RE: **HLP Endodontics, 10429 Lagrima Del Oro NE**
Grading and Drainage Plan
Engineer's Stamp Dated 6-29-15 (File: F21-D063)

Based upon the information provided in your submittal received 6-29-15, the above referenced plan is approved for DRB Action for Site Development Plan for Building Permit. It is also approved for Building Permit with the following conditions prior to CO Approval:

**RE: Grading and Drainage Plan
F21-D063
10429 Lagrima del Oro**

**RE: HLP Endodontics, 10429 Lagrima Del Oro NE
Grading and Drainage Plan
Engineer's Stamp Dated 6-03-15 (File: F21-D063)**

ENGINEER'S SEAL 6/29/15 DAVID SOULE P.E. #14522	10429 LAGRIMA DE ORO DENTAL OFFICE CONCEPTUAL GRADING AND DRAINAGE PLAN	DRAWN BY DEM DATE 4-14-15
	 Rio Grande Engineering 1808 CENTRAL AVENUE SUITE 201 ALBUQUERQUE, NM 87106 (505) 872-0088	SHEET # 1 of 2 JOB # XXXXX

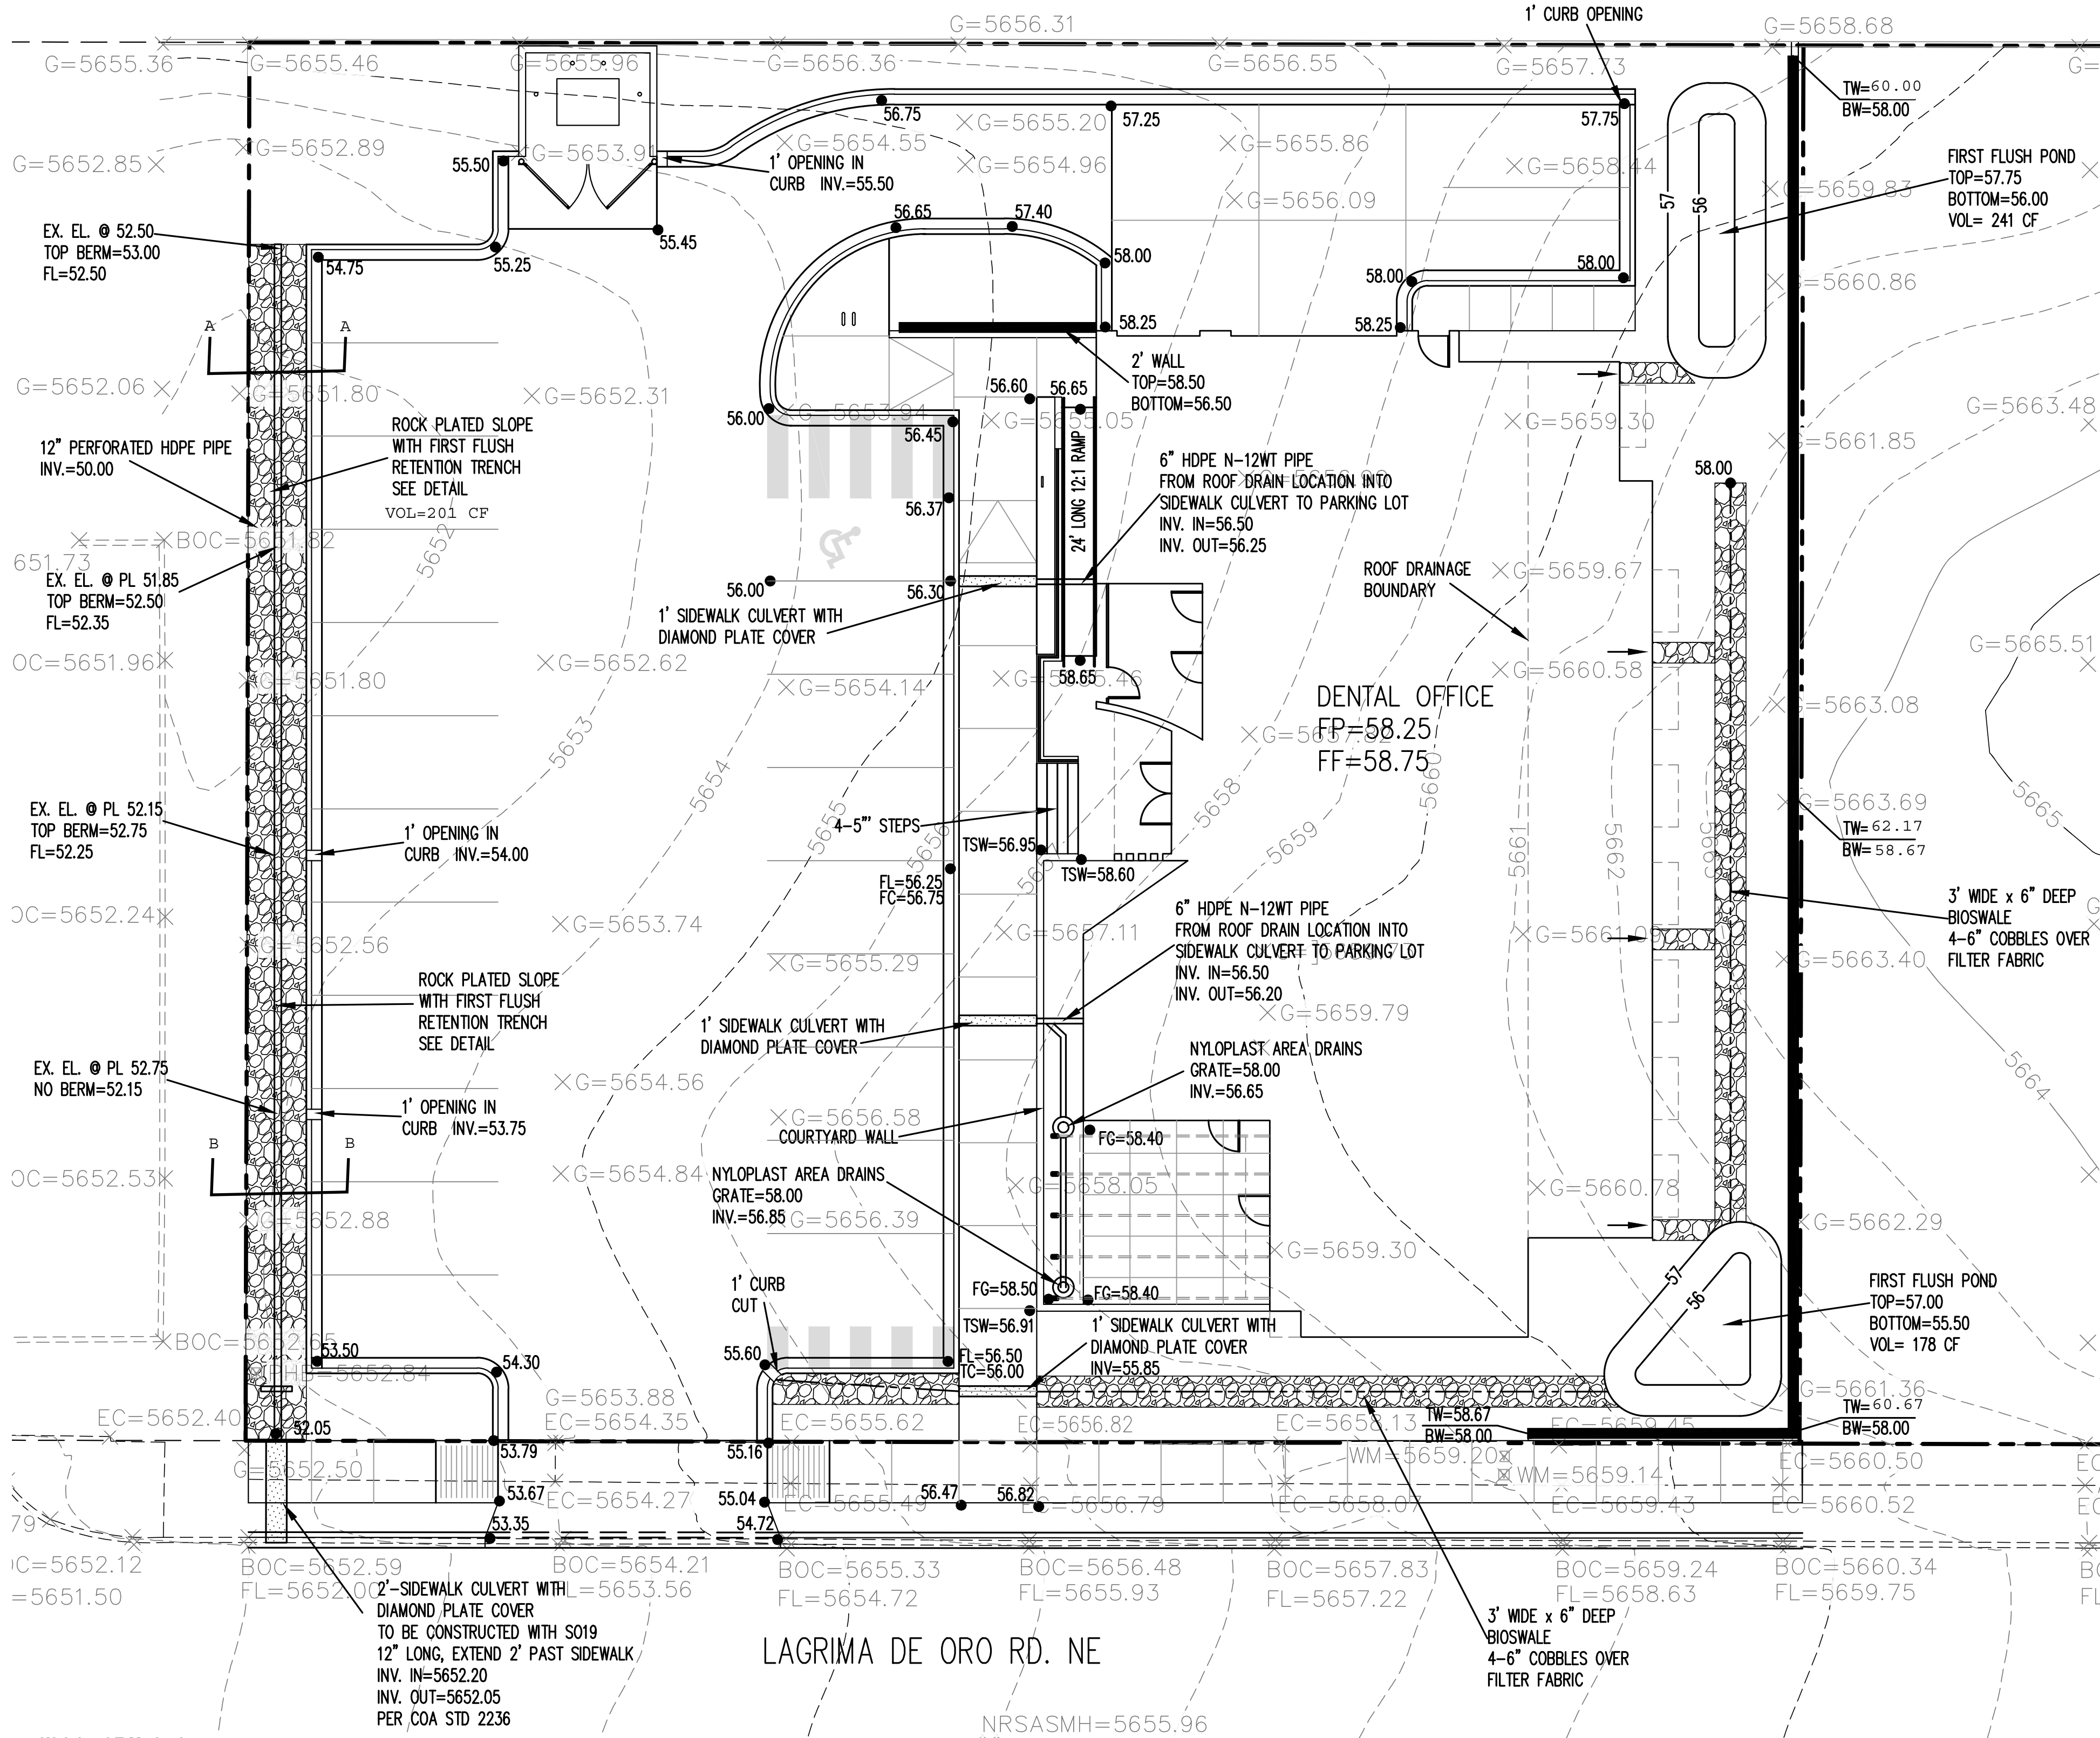
- A. On cross-section B-B, indicate a vertical dimension for the swale similar to A-A to ensure that there is a defined swale size. Provide minimum vertical depth of 8 inches.
- B. Provide a site benchmark.
- C. At the southwest corner of the parking lot, there is a 53.50 elevation which is a low spot and looks like it needs a curb cut. Provide a curb cut at this location.

- 1) The swale along the west property line is listed as 1 foot deep with a 6-inch check dam. The middle elevation shown only has a difference in elevation of 0.5 feet between berm and flowline. The invert elevations for the sidewalk culverts also appear to be 30 feet too low from what the elevations are intended to be. Revise as needed, and provide slope of swale as applicable. On cross-section A-A, it would be helpful to show the one foot depth and the 6-inch check dams that are installed every 30 feet. If the check dams are 30 feet apart, label them as such. Also provide the flowline elevations at each of the curb cuts along the west edge of the parking lot. Show the relationship between the curb cut elevation and depth of swale to ensure drainage to swale. Provide riprap for the short distance from the curb cut to the rock swale.

- 2) Reference COA Standard Drawing 2236 for the construction of the sidewalk culvert.
- 3) Approximately 10% of the site drains to the first flush ponds on the east side as indicated by the roof drainage boundary. An insufficient percentage of the first flush volume is provided along the west side even though this is where the vast majority of the site drains. Is there opportunity to provide first flush volumes within the landscaped areas at the northwest and southwest corners of the site?

- 4) Where it says "Volume – 24 cf per dam", add language indicating that this is for the "first flush", and provide the total volume for the first flush within this area.

-
- 5) On cross-section A-A along the west property boundary, the slope to the west of the berm be called out as 3:1 since it is right along the property boundary without protection.
 - 6) Call out depth of 4-6" cobble within the bioswale.
 - 7) The referenced detail sheet in the letter also needs to be provided.

1. We have revised the plan due to the slope concerns, we have proposed a first flush retention trench rather than the small ponds. The trench allows for the slope and swale to be constructed, the volume of the trench is provided.
2. We have added the reference.
3. We have modified the plan such that all the flow passes through a first flush system.
4. We have revised the plan to provide the first flush with a trench and have labeled as such.
5. We have revised the cross sections and added slope protection.
6. We have labeled the bio swale as 4-6" fractured rock.
7. There is no detail sheet, the comment was a remnant from a different response letter.
